RE: Arlington Land Trust – Weston & Sampson Resiliency Review

BSC Group is in receipt of the resiliency review related to the East Arlington Mugar site (Thorndike Place) conducted by Weston & Sampson, dated January 20, 2021, on behalf of the Arlington Land Trust. BSC has reviewed the Weston & Sampson memorandum and offers the following responses and clarifications related to the information presented. The memorandum section headings are included for ease of review.

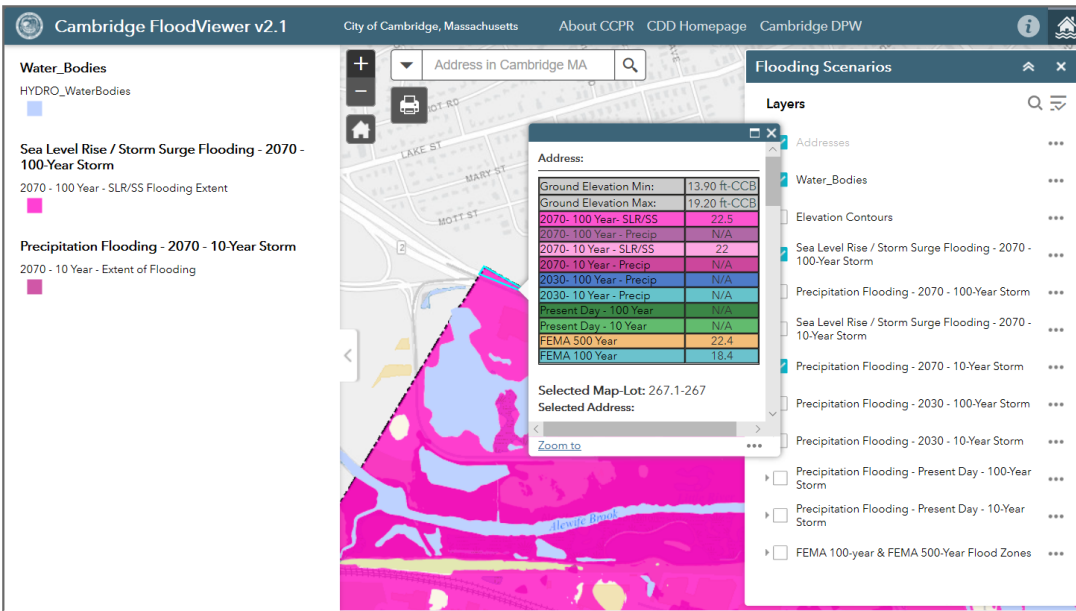
- Figures 1 through 7 of the Weston & Sampson memorandum depict scenes after previous storm events. It is important to note that the figures primarily depict locations east of the Minuteman Bikeway, adjacent to Alewife Brook, located within the FEMA Floodway and at elevations approximately 3 – 5 feet lower than the area of the Site proposed for development. These Figures are not representative of the area of the Site proposed for development.
